HOUSTON PLANNING COMMISSION

AGENDA

NOVEMBER 10, 2016

SWIMMING CLUB	9.0 parking spaces per employee	1 EMPLOYEE = 9 SPACES REQUIRED
		0 SPACES PROVIDED ON SITE 10 SPACES PARALLEL TO SITE IN THE RIGHT OF WAY

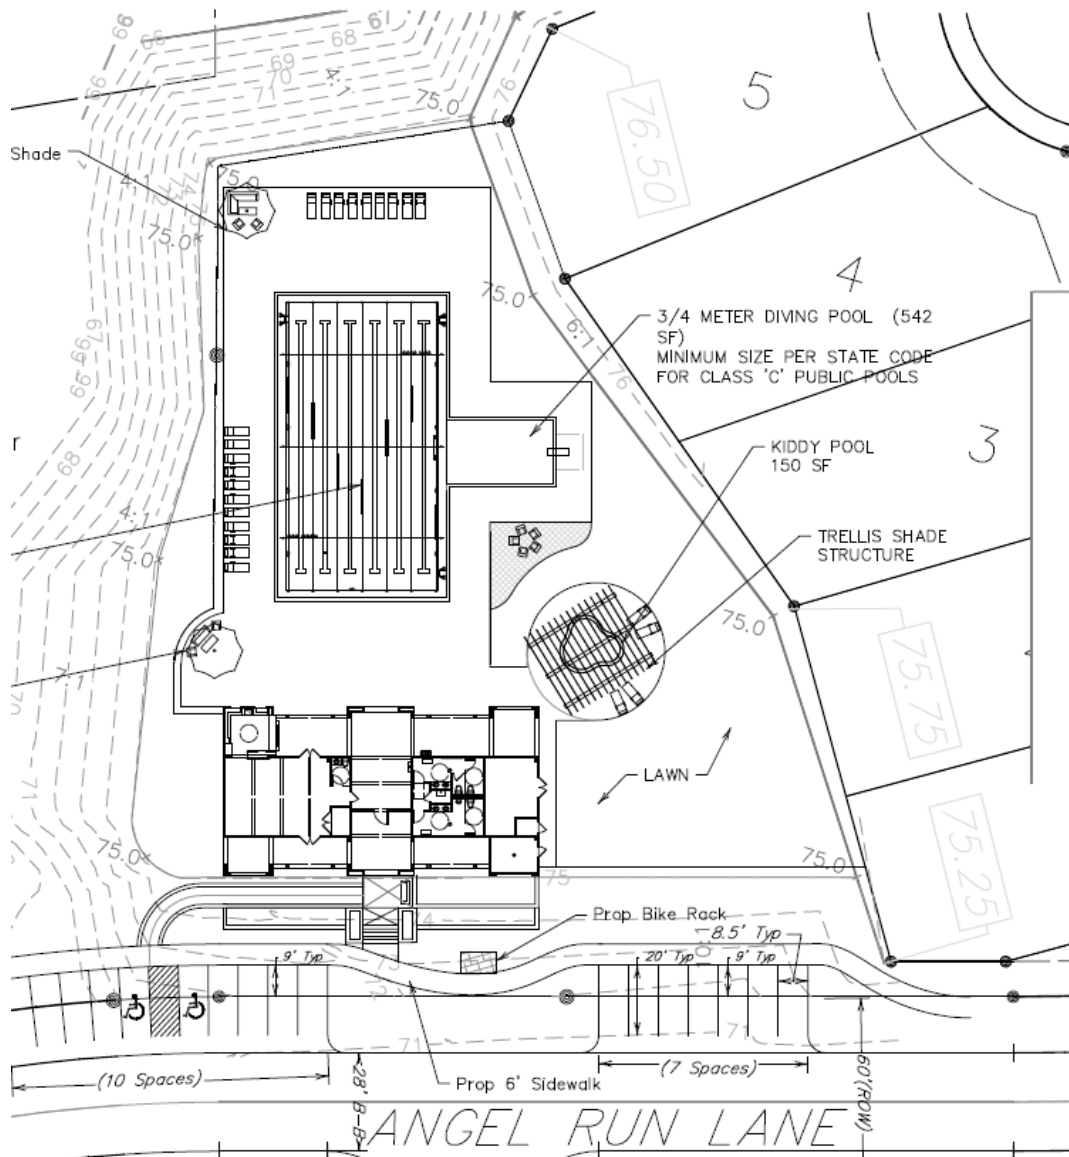
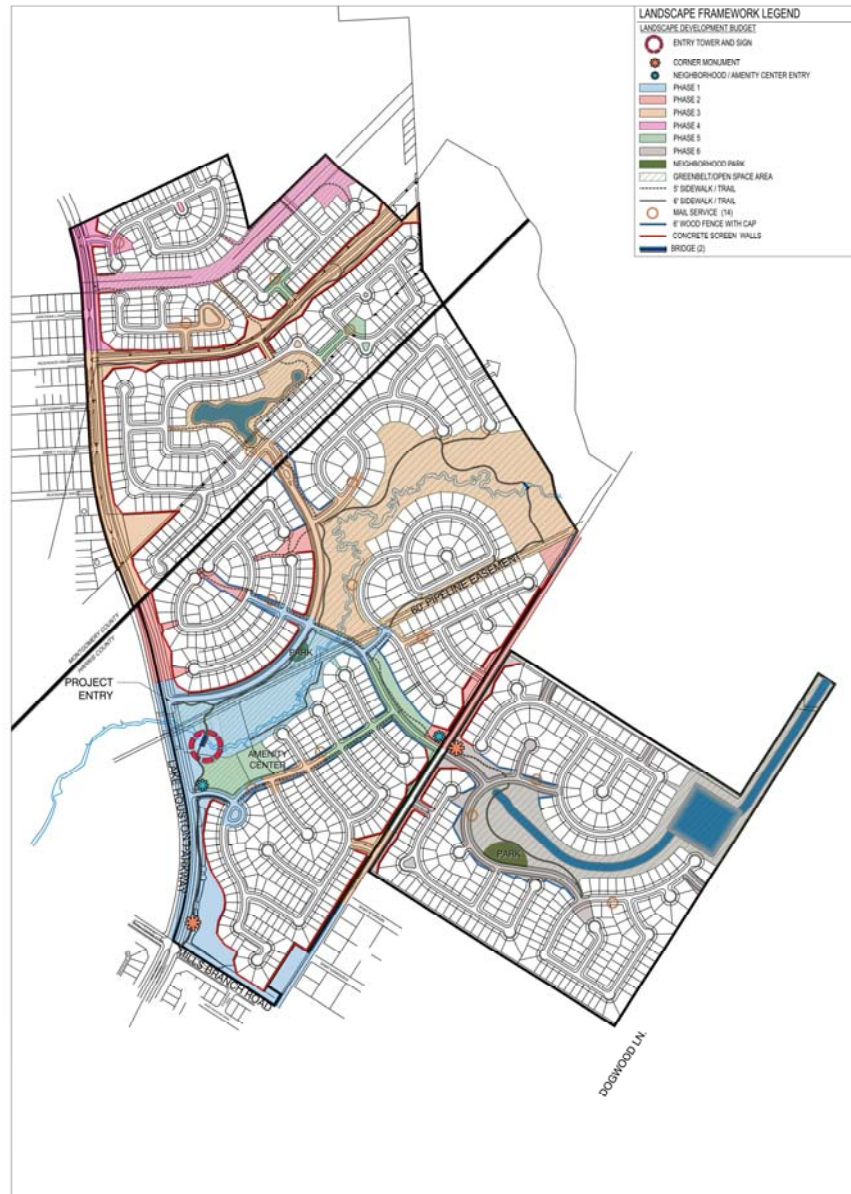
Staff recommendation: Deny the requested variance request to not to provide the required parking spaces within the site but to allow the use of 10 parking spaces located within the ROW (Angel Run Lane) to fulfill the parking requirement and the required bike rack will be provided on site.
